Technical Service Bulletin

MODEL(S) AFFECTED: Tennant M20, T20, T7, T5, T3 (Only machines equipped with FaST)

SUBJECT: Hoses on FaST-PAK cartons kinking when the FaST-PAK carton is installed onto the machine, restricting or stopping the flow of detergent to the detergent pump.

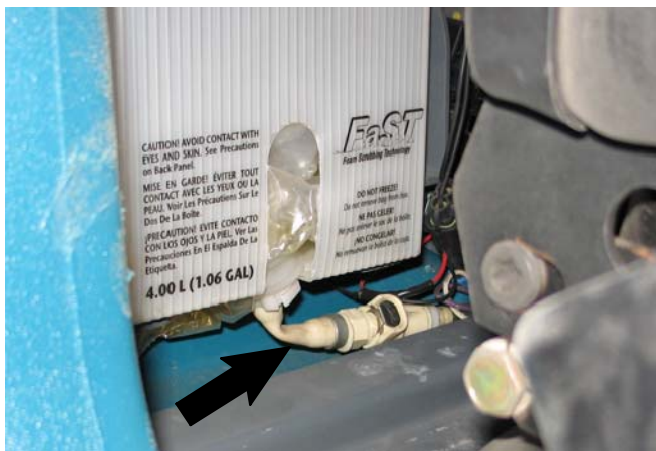
FaST-PAK carton hose must not be kinked as shown above.

PURPOSE: Install conduit onto FaST-PAK carton hose to prevent the hose from kinking.
